WINDROSE
 SHEET 8-1
 SUPPLEMENT: AILERON STOPS AND ADJUSTABLE "FLAP" SETTINGS.
 OCT 1986

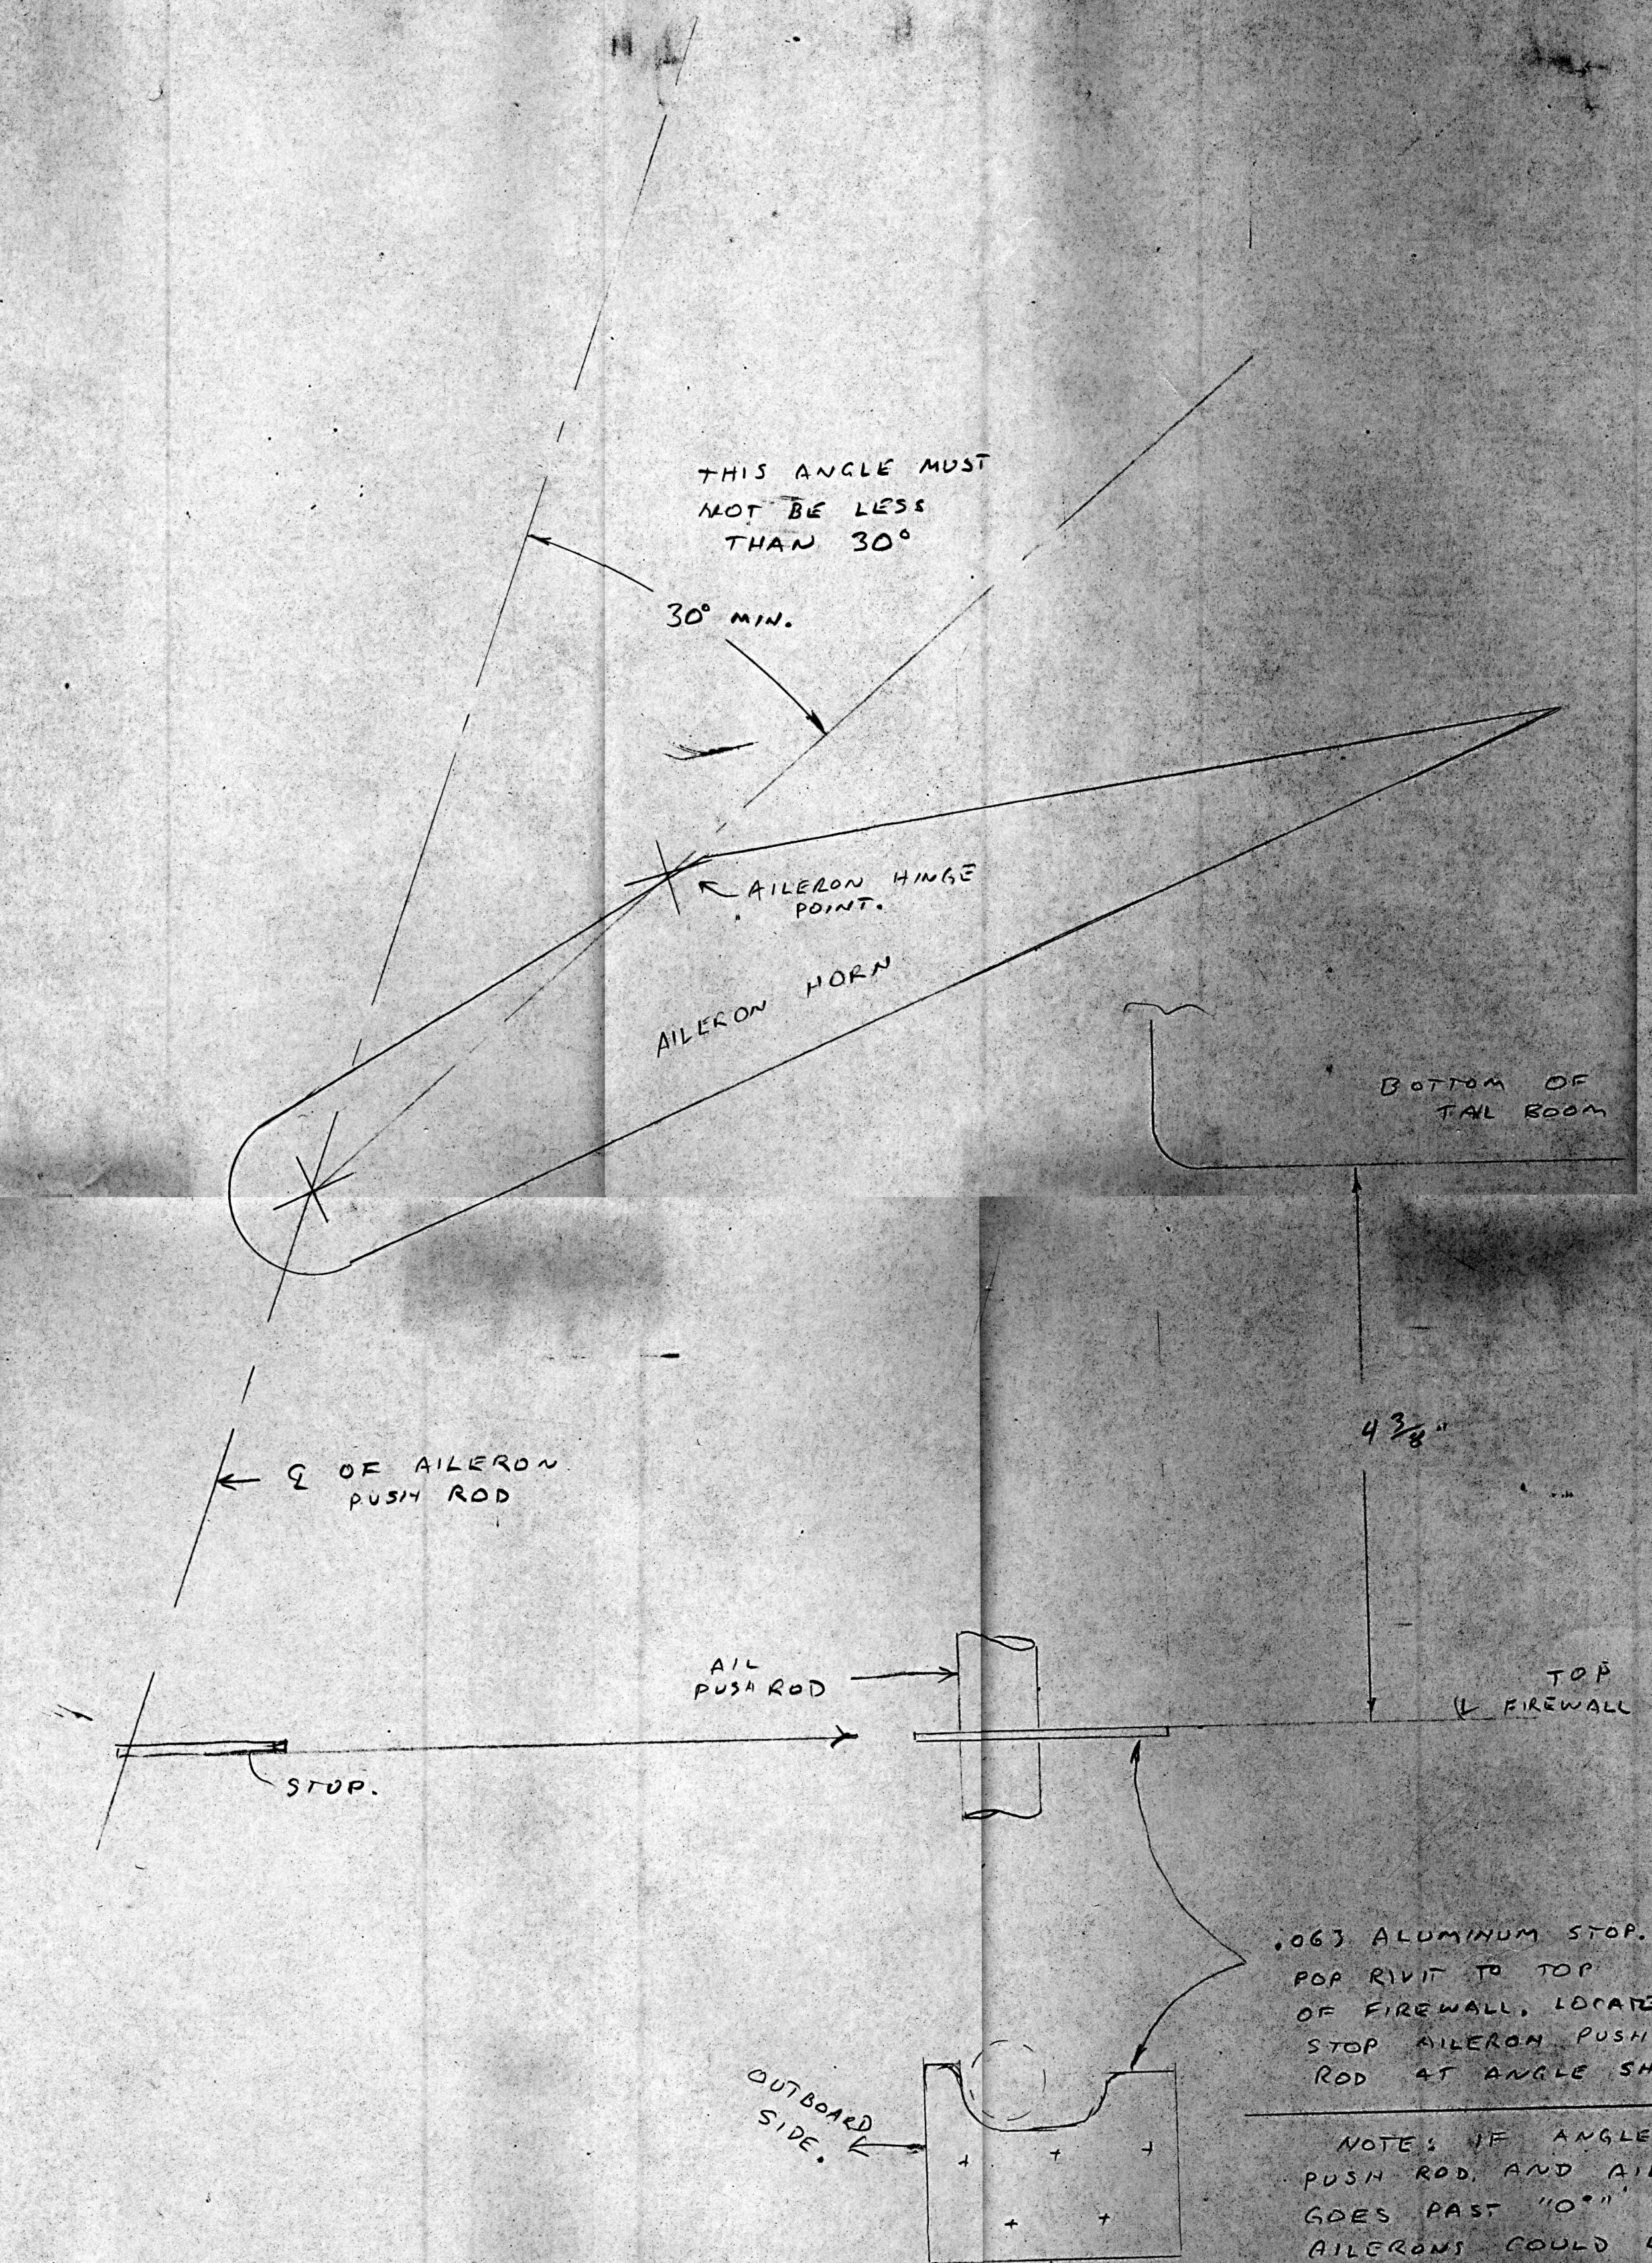
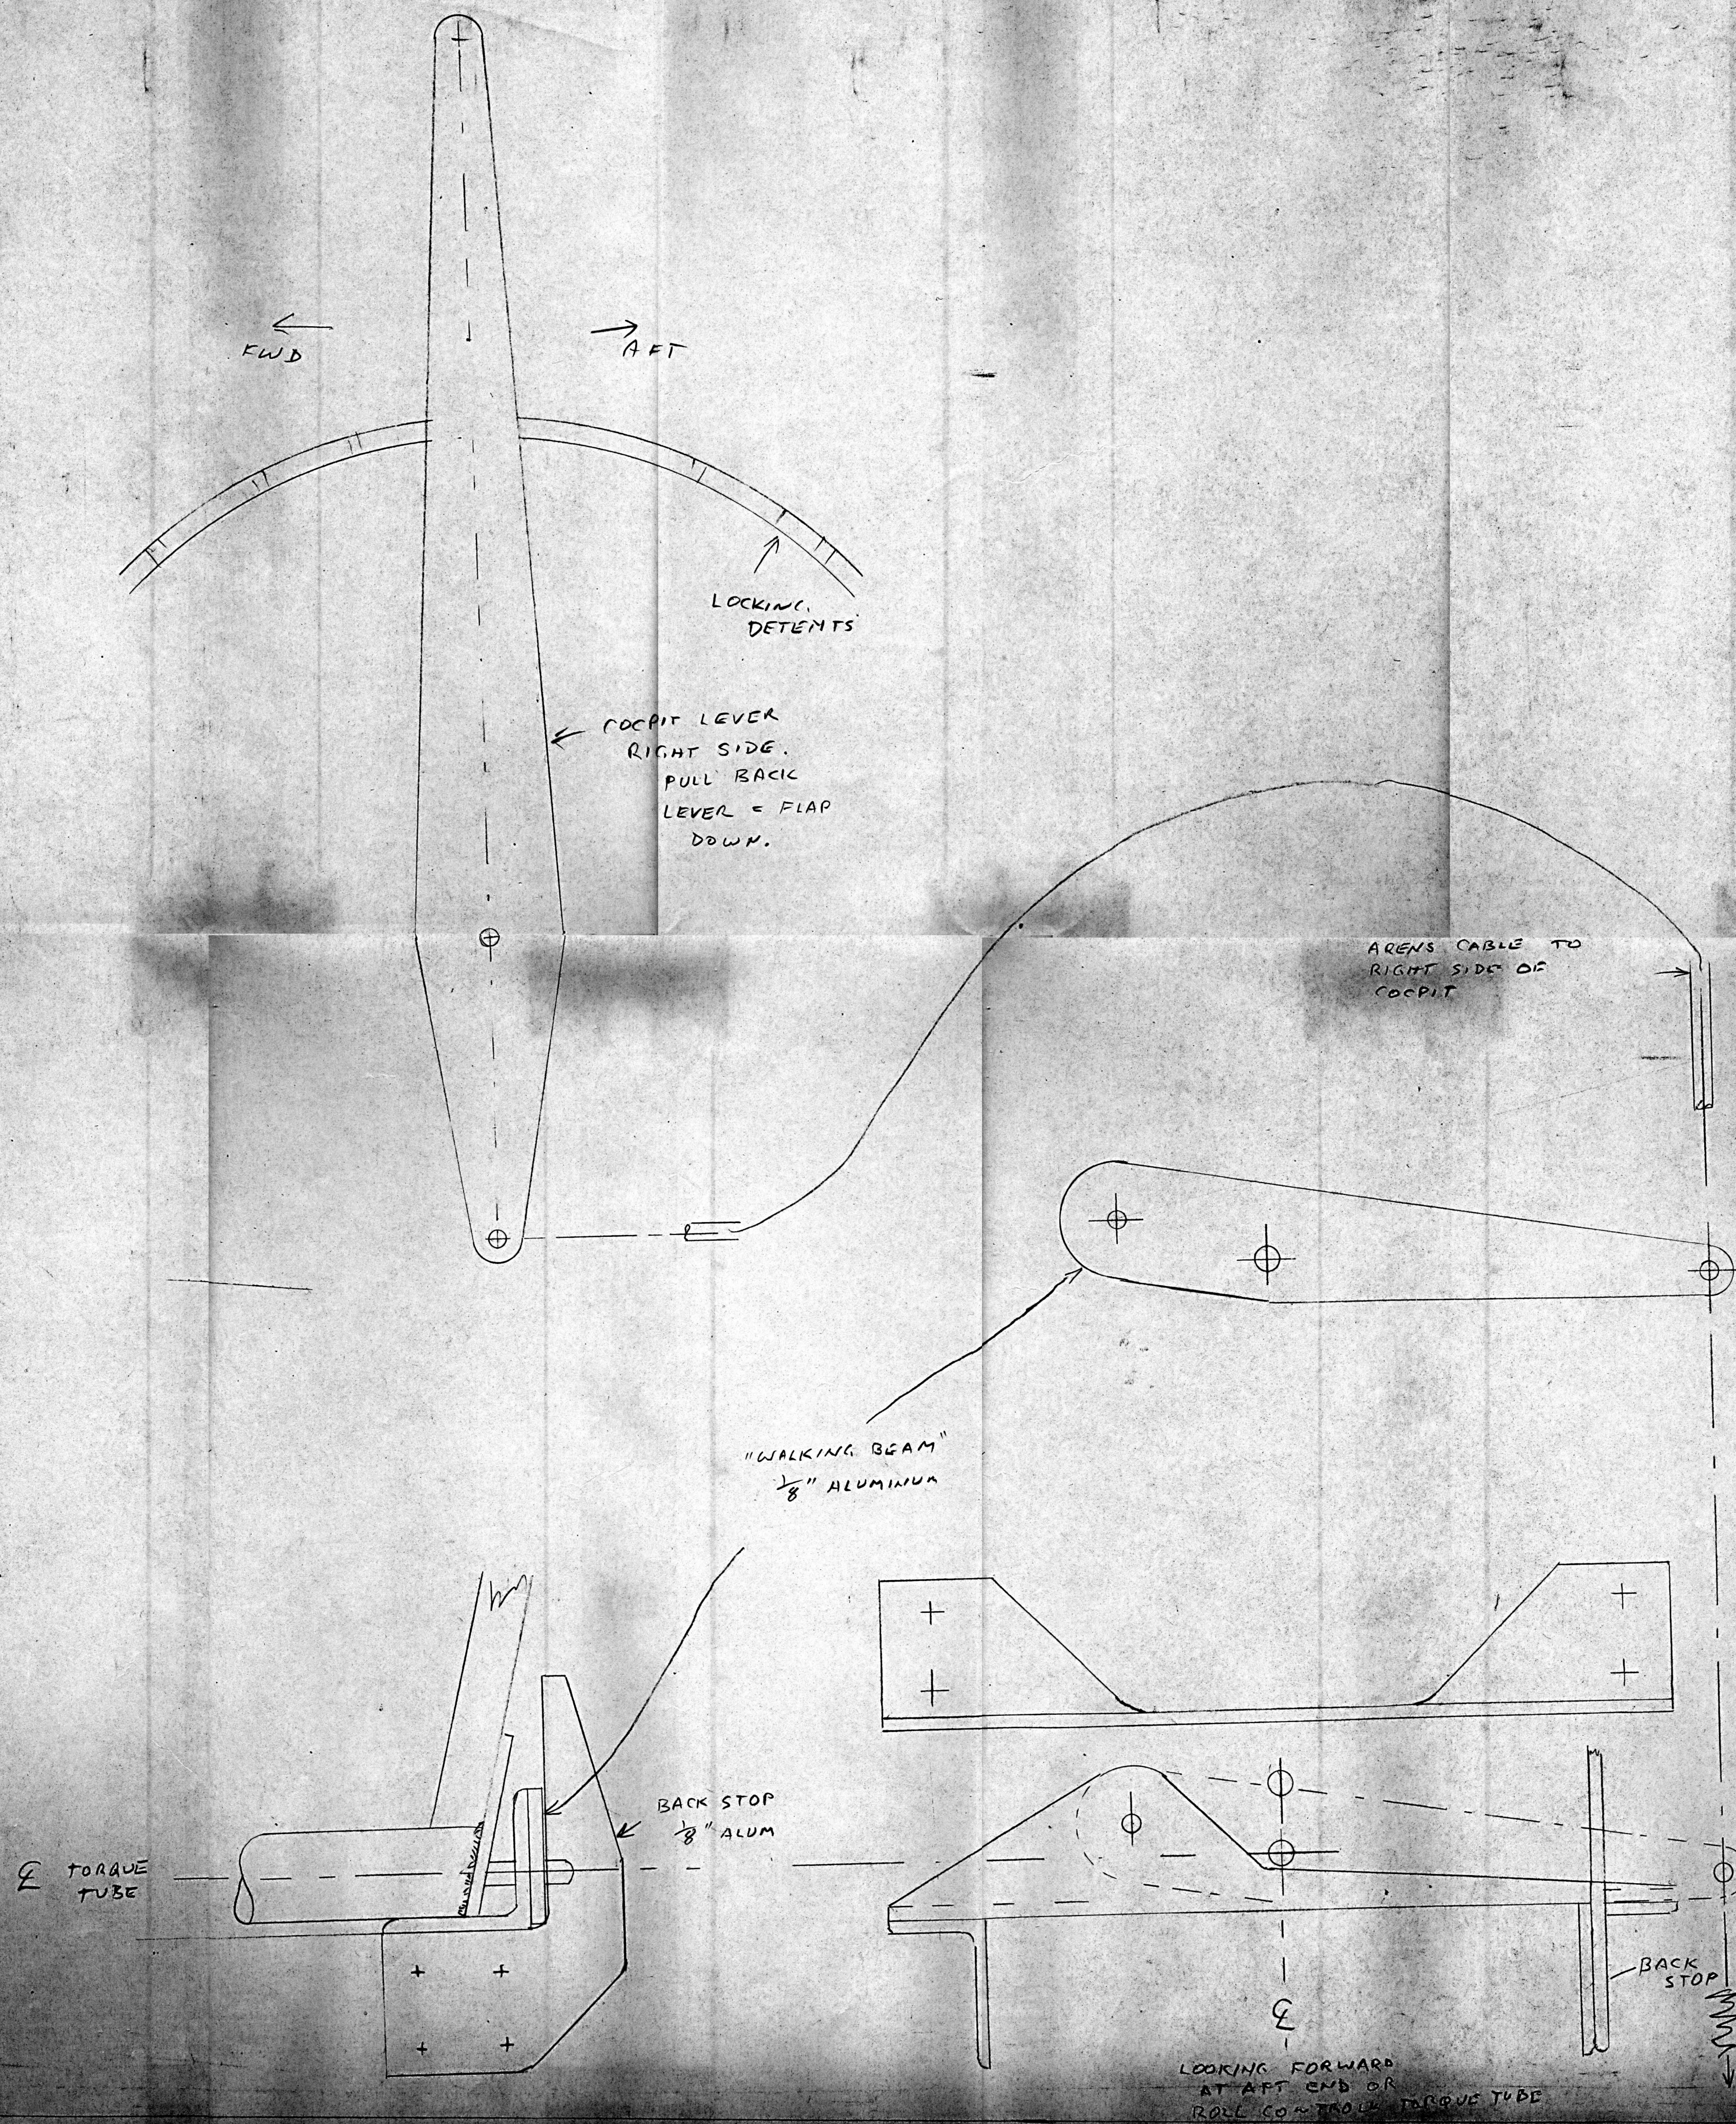
NOTE: ADJUST FLAP TRAVEL UP AND DOWN A FEW DEGREES. UP FLAP LIMITED BY HORN TO PUSHROD ANGLE. DOWN FLAP LIMITED TO ADEQUATE ROLL CONTROL. APPROXIMATELY 10°.

NOTES: IF ANGLE OF PUSH ROD AND AILERON GOES PAST "10°" THE AILERONS COULD LOCK AT FULL TRAVEL. MIGHT MAKE FOR A VERY EXCITING LANDING.
